ADDENDUM NO. 1

Project Number: 2025-11135

Project Title: Route 7 HPT Improvements Phase 2

Agency: Spokane Transit Authority

SHEET NO:
C-203
SHEET

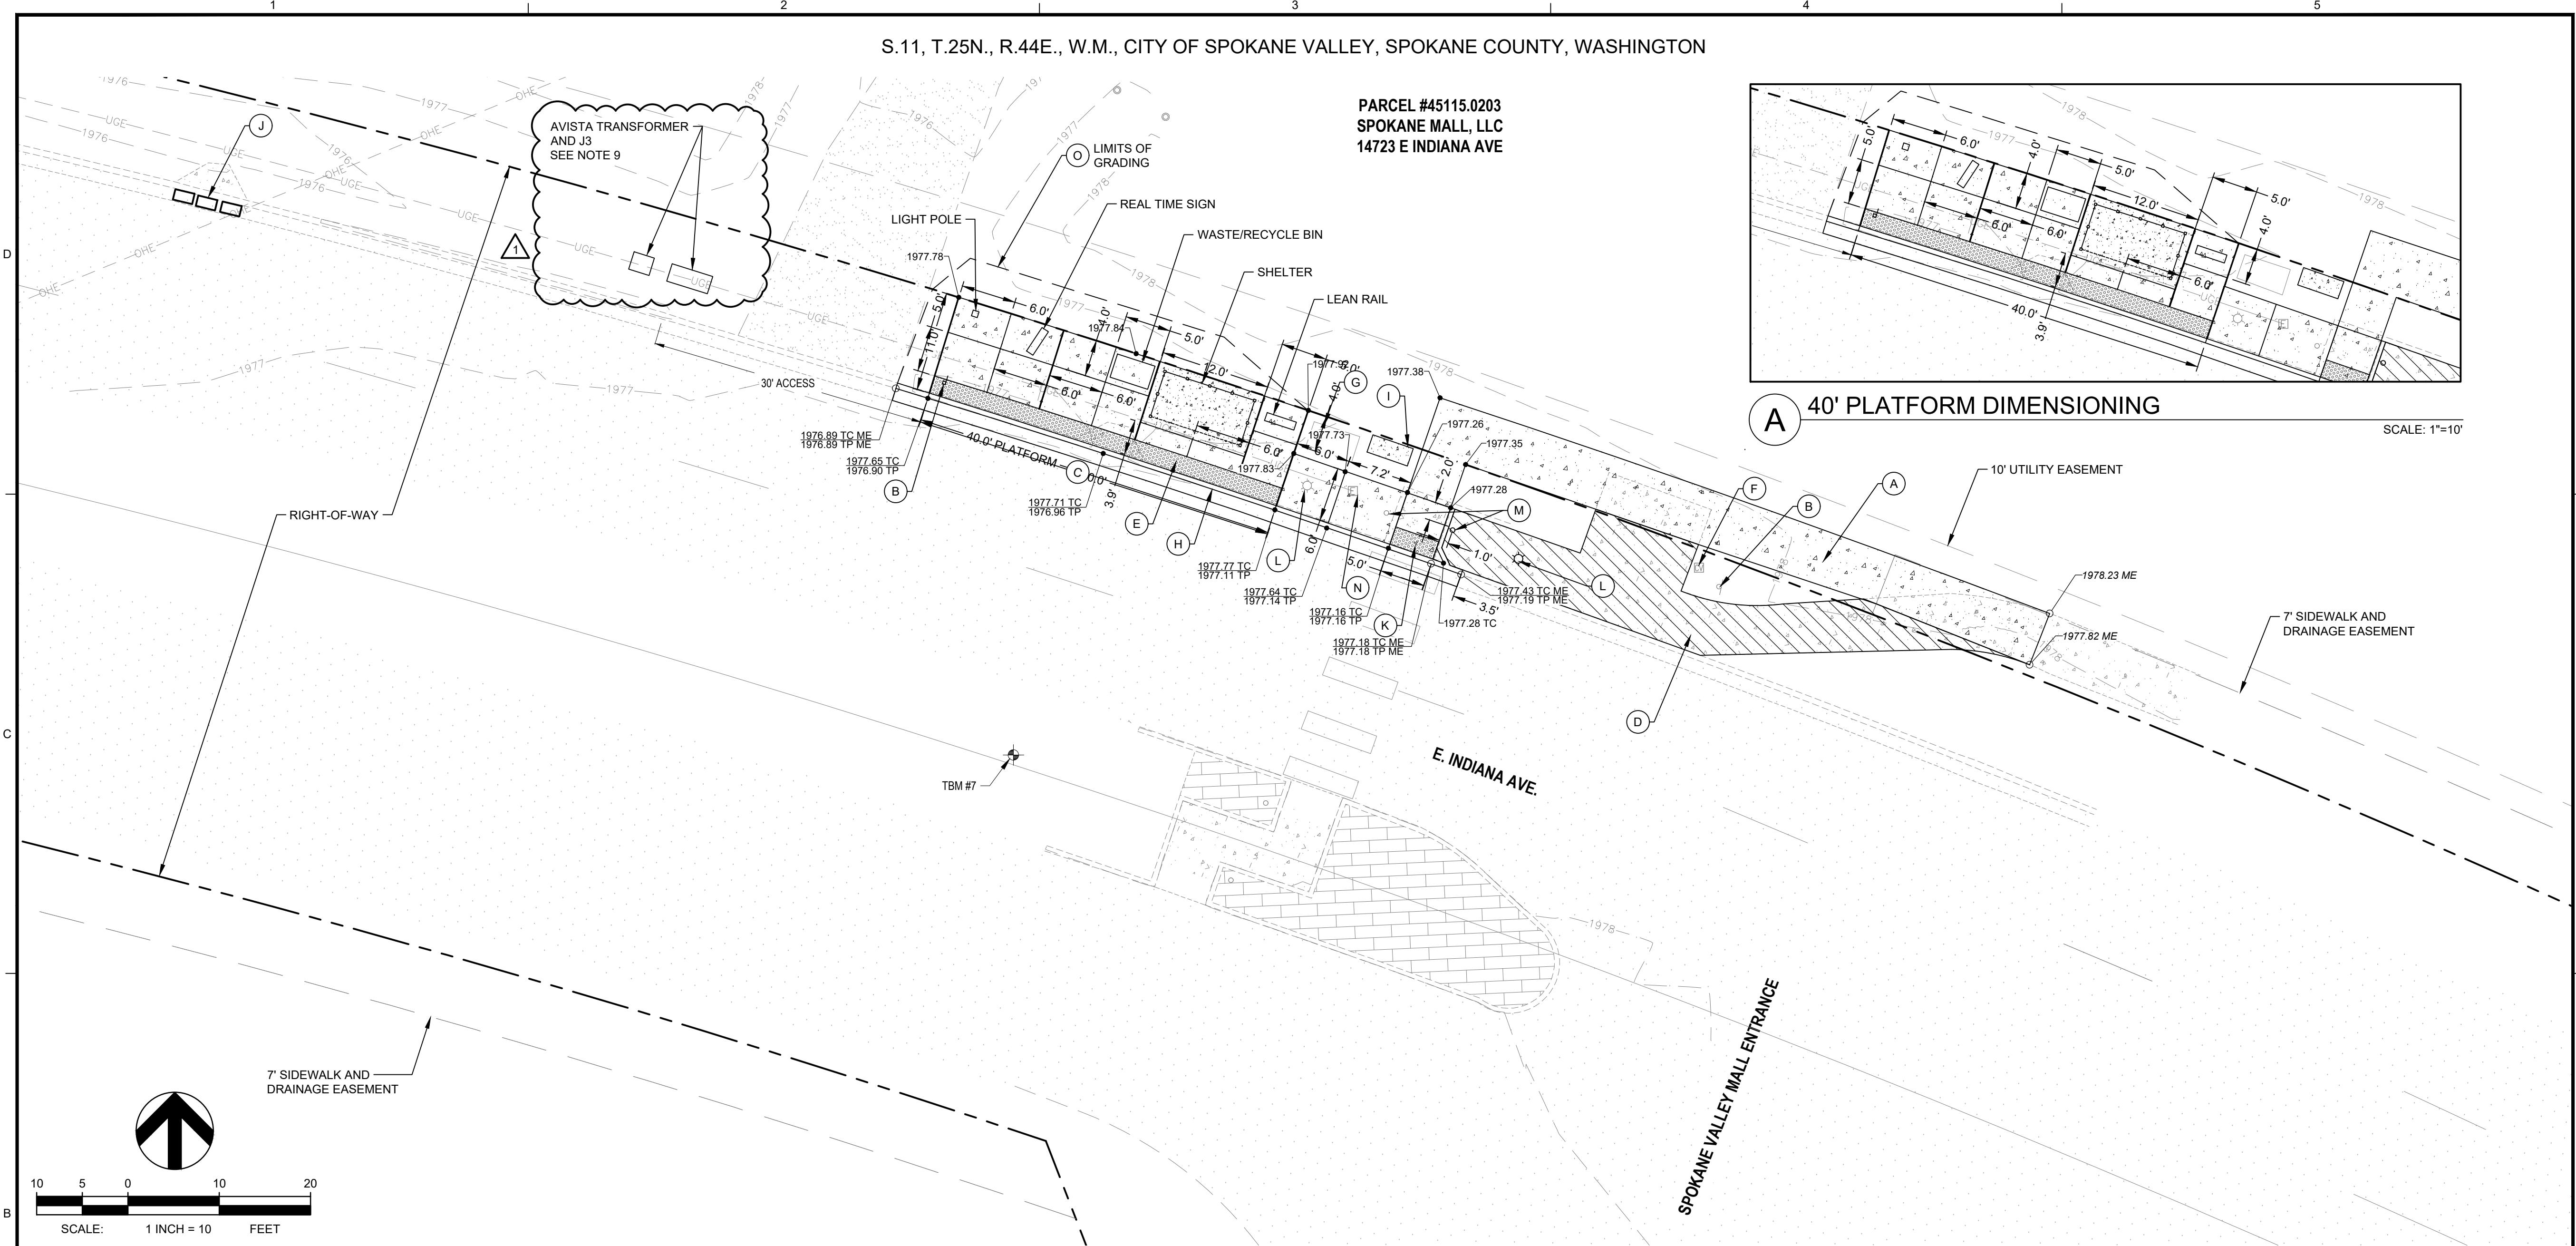
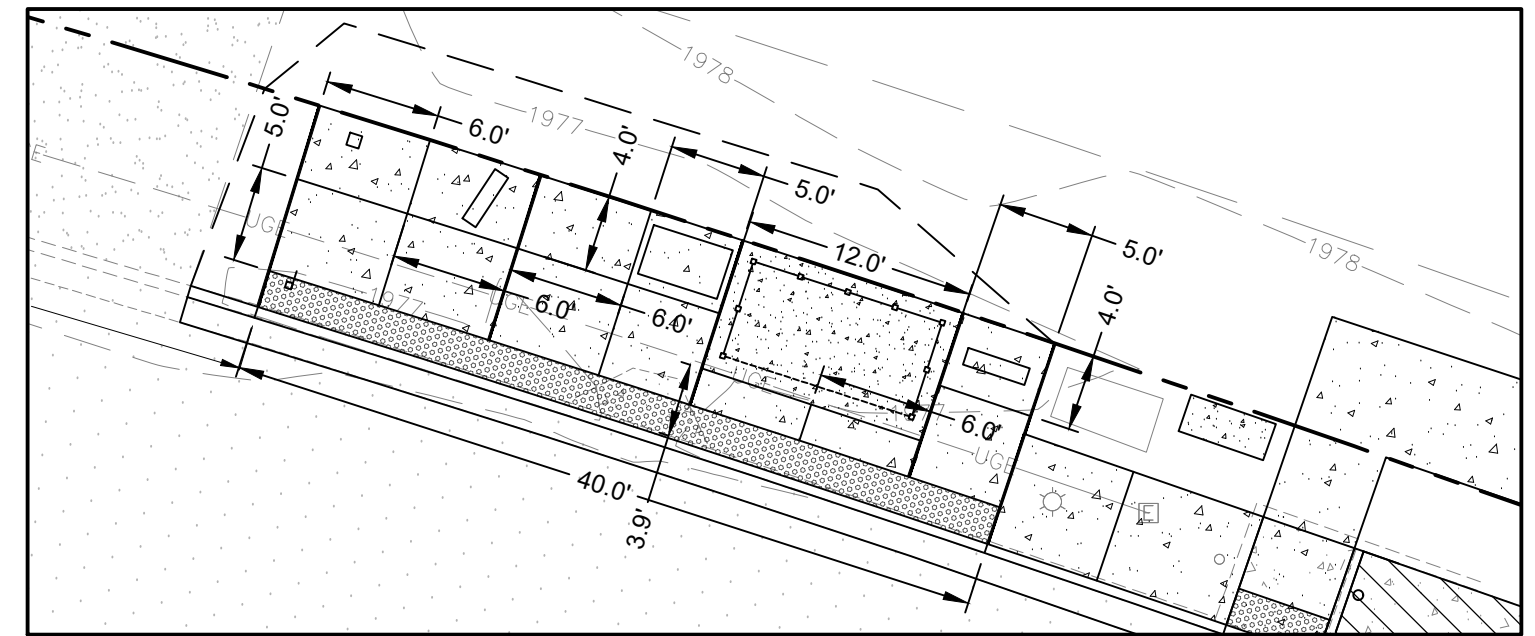
Drawing C-203 – Keynote I indicates locations of communication and power cabinet footings. These details conflict with drawing E-202 detail A1.

Please clarify correct location for cabinets. **Civil and Electrical plans updated to correct discrepancy. See revision 1 to corresponding drawings.**

- REMOVE EXISTING CURB AND GUTTER, CURB INLET, GRASS AND TOP SOIL AND INSTALL HIGH PERFORMANCE TRANSIT STATION IMPROVEMENTS PER DETAIL 2, SHEET C-300, WITH UPDATED DIMENSIONING AS SHOWN ON DETAIL A. THIS SHEET, SEE DETAIL 5, SHEET C-301 FOR FOUNDATION PLAN FOR ALL IMPROVEMENTS RELATED TO STATION IMPROVEMENTS. SEE PLAN VIEW FOR ALTERATION OF STATION PLATFORM IMPROVEMENTS TO FIT 40' PLATFORM LENGTH, ADJUST FOUNDATIONS AND CONDUITS AS NEEDED.
